**Seismic Walkdown Checklist (SWC)**

Equipment ID No. 1-1805-Y3-1D6E Equip. Class<sup>12</sup> 16

Equipment Description RHR 150 VLV INVERTER

Location: Bldg. CONTROL Floor El. 180 Room, Area B49

Equipment ID No: 1-1P06-B3-CAB Equip. Class<sup>12</sup> 16  
 Equipment Description Battery Charger 1AD1CB  
 Location: Bldg. CB Floor El. 1P0 Room, Area CB 52  
 Manufacturer, Model, Etc. (optional but recommended) \_\_\_\_\_

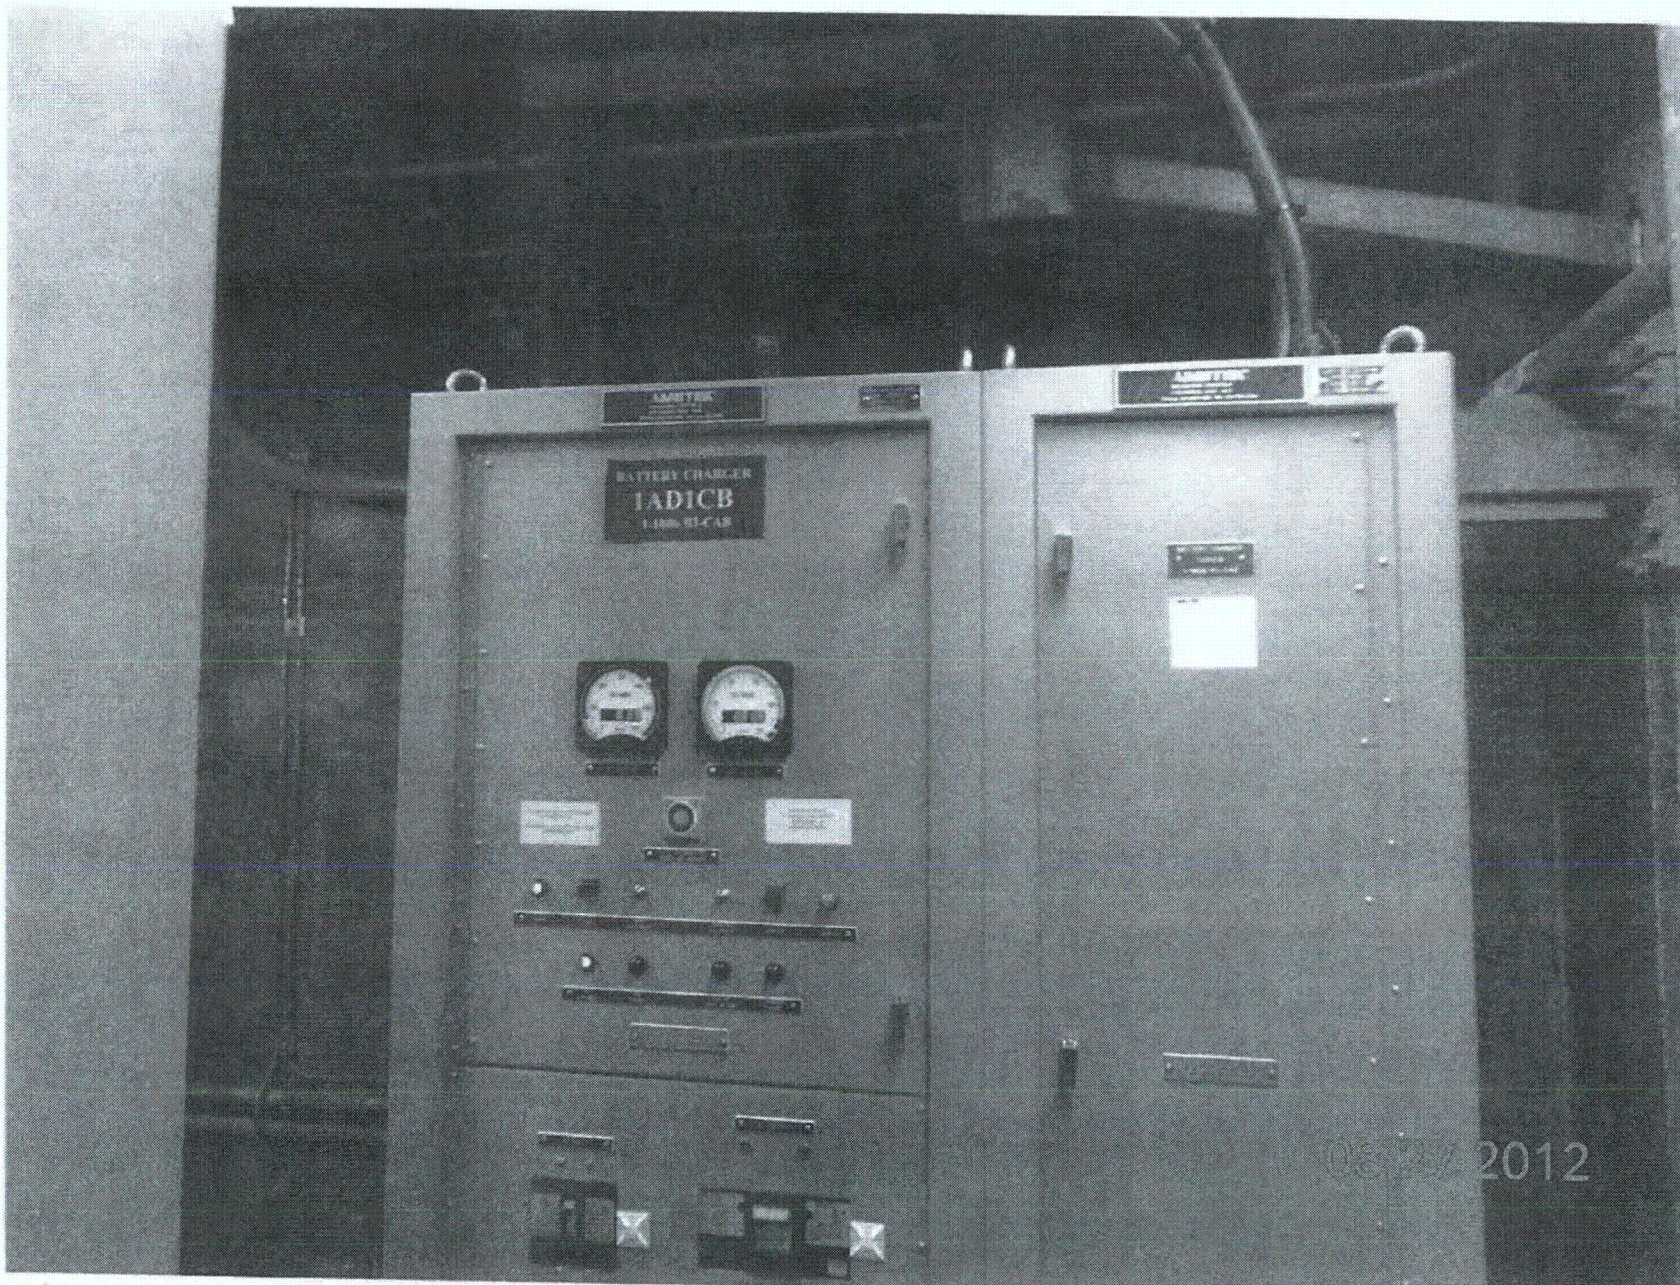
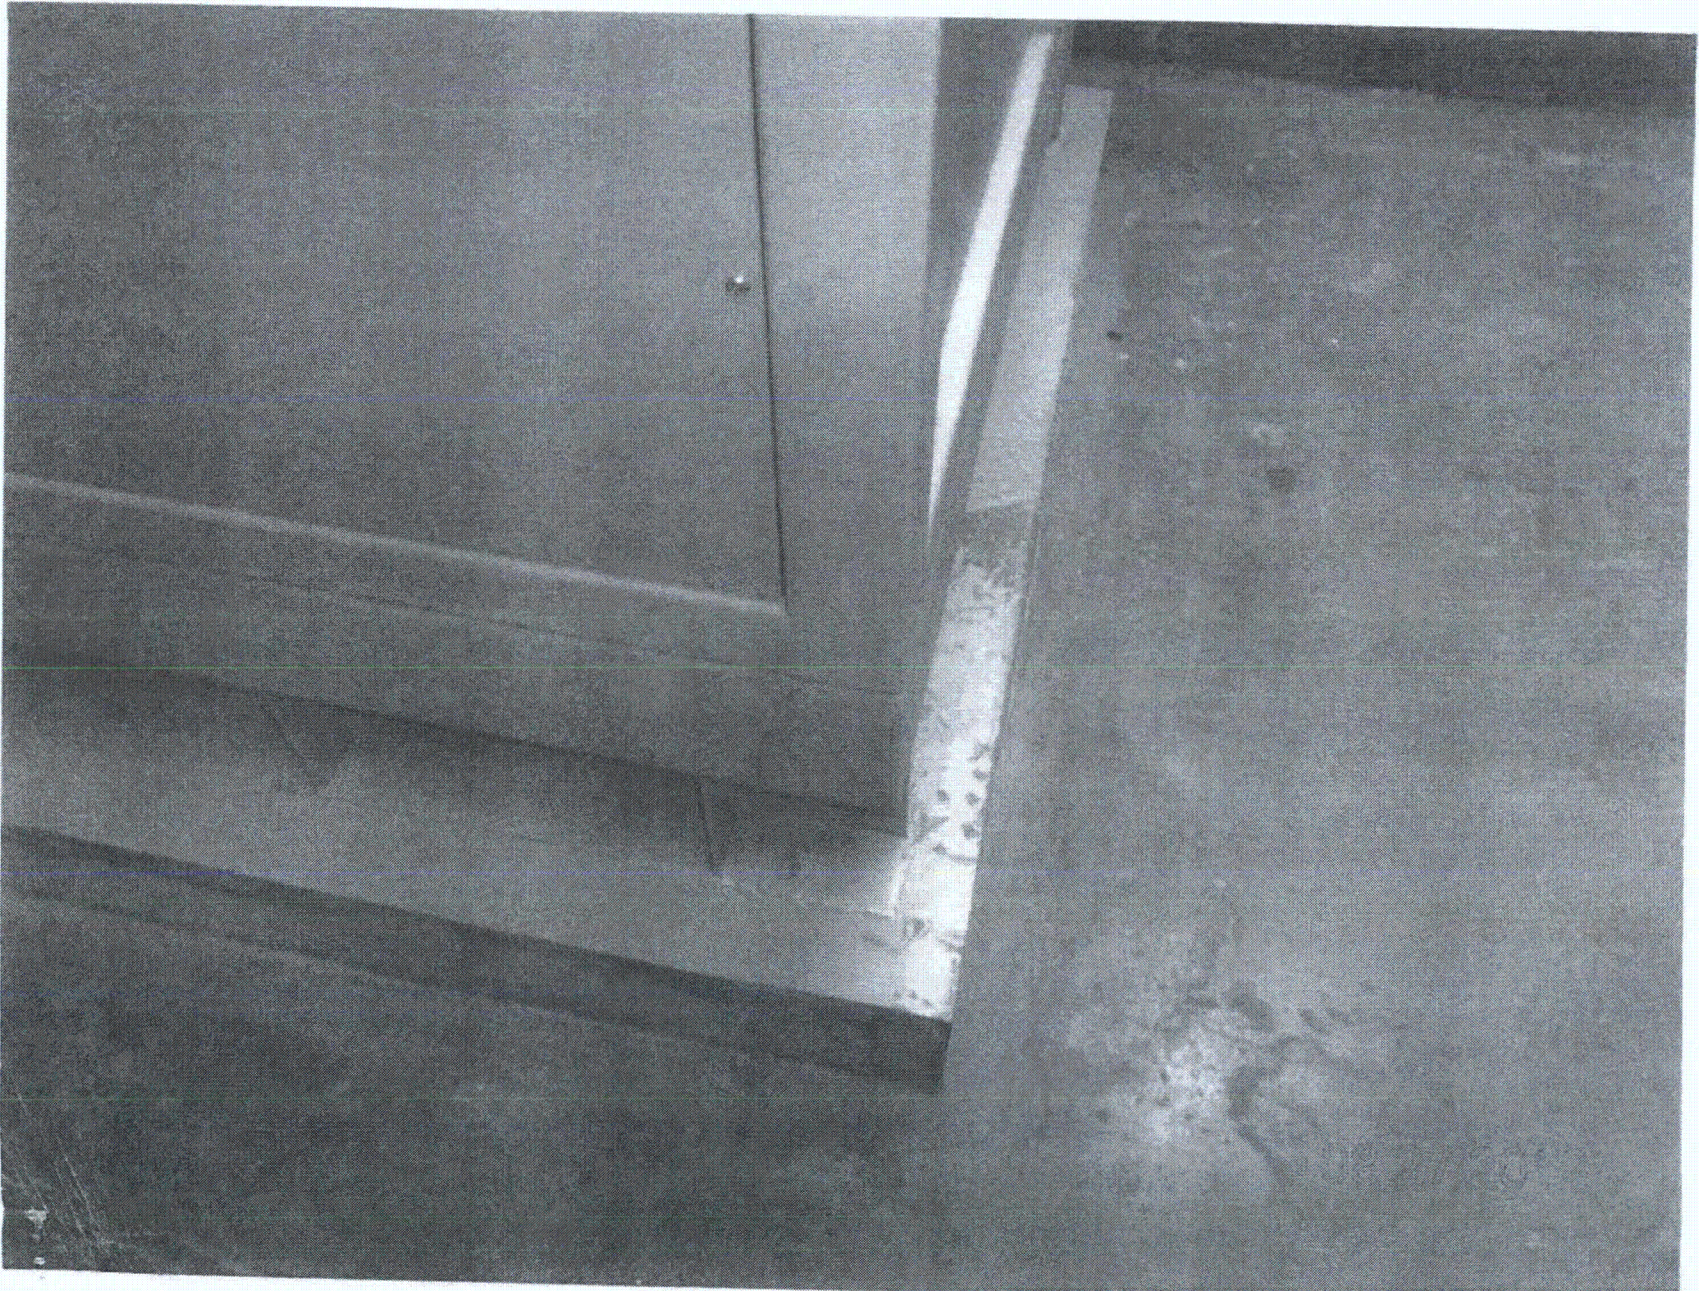
2. Is the anchorage free of bent, broken, missing or loose hardware?  Y  N  U  N/A  
*Weld Battery Charger Base frame to embed steel at four corners*

Equipment ID No. 1-1806-Q3-DA2 Equip. Class<sup>12</sup> 14

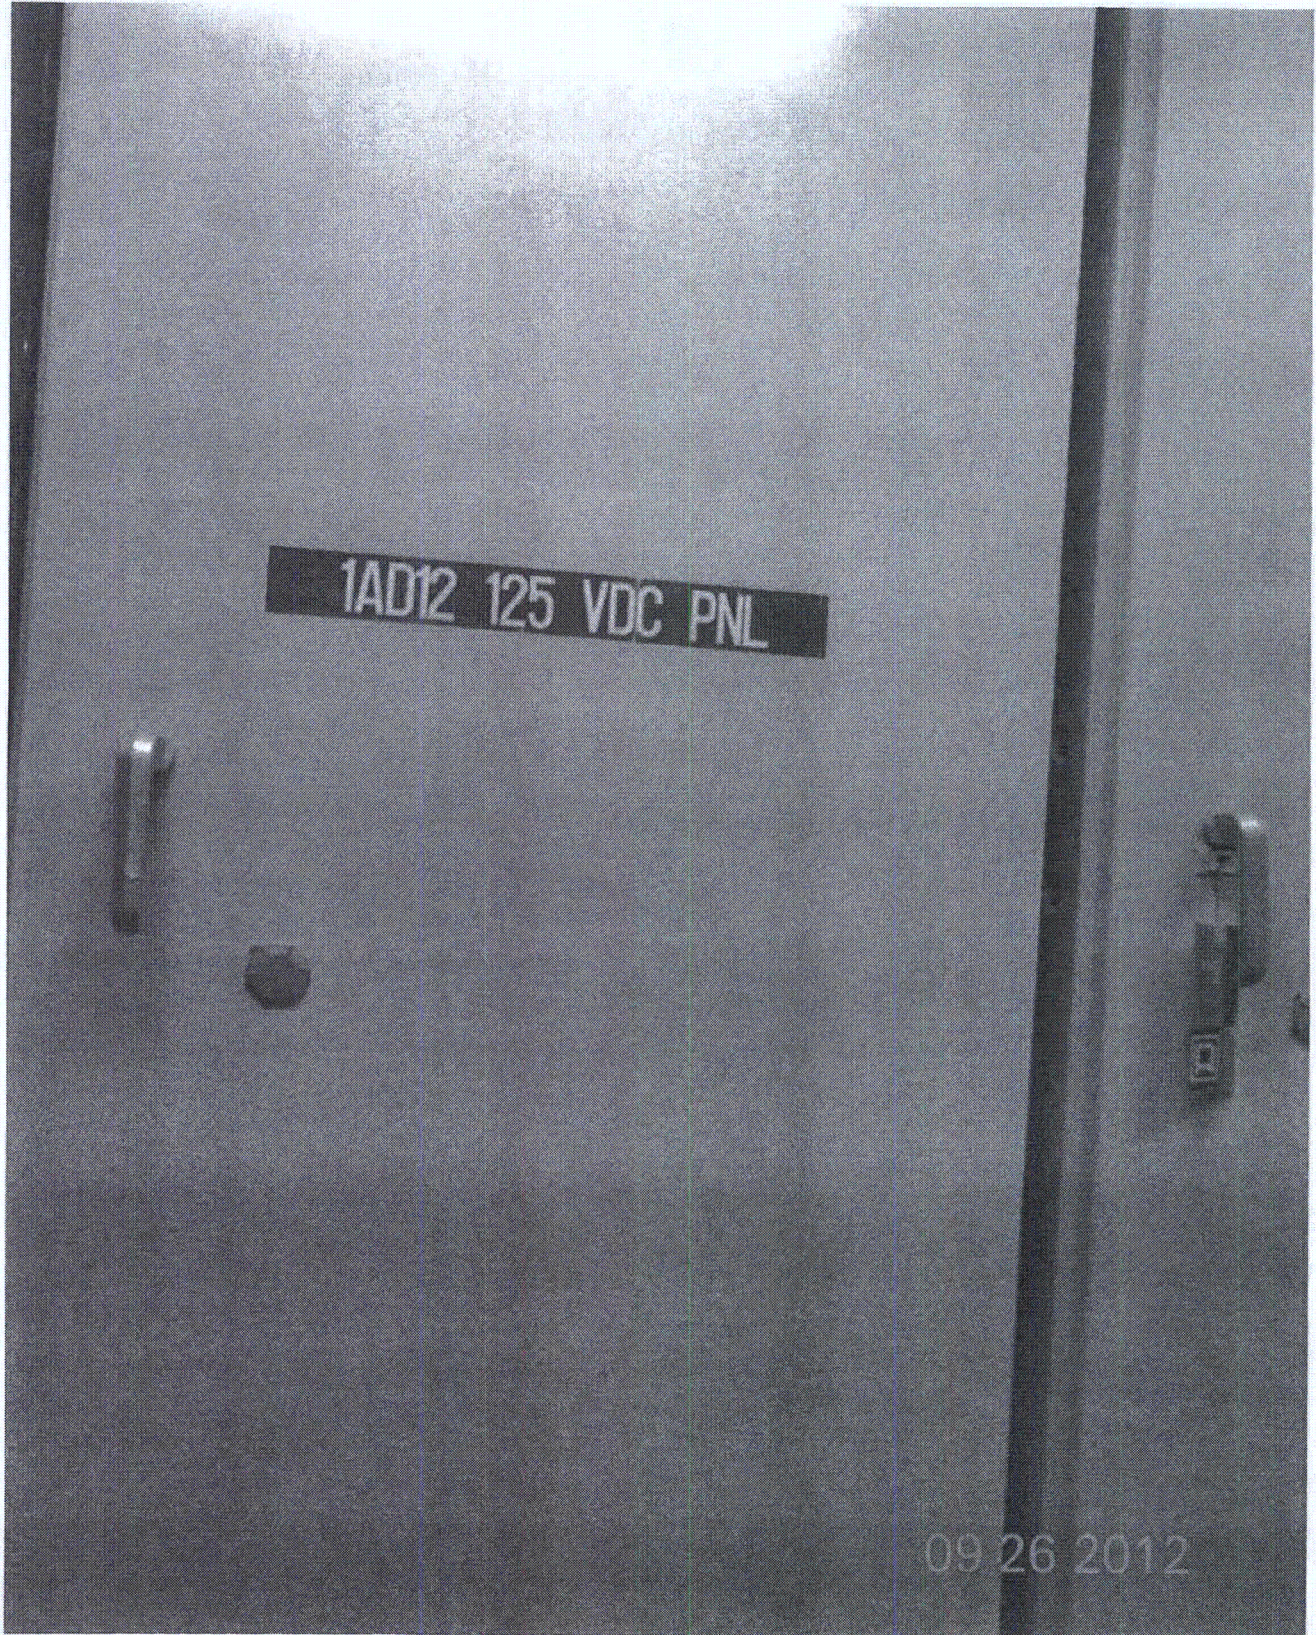
11. Have you looked for and found no other seismic conditions that could adversely affect the safety functions of the equipment? Y  N  U   
A visual inspection of the internal components of this cabinet was performed to check for seismic adequacy to include any evidence of internal components not adequately secured, checked to ensure fasteners connecting adjacent cabinets were in place, and evidence of other adverse seismic conditions. One fastener that connects the inner frame is missing. See "Comments" section for details.

It was found that one (1) bolt that connects the inner frame with the cabinet was missing. An evaluation of this condition needs to be performed to determine seismic adequacy. Condition report 534560 was generated.
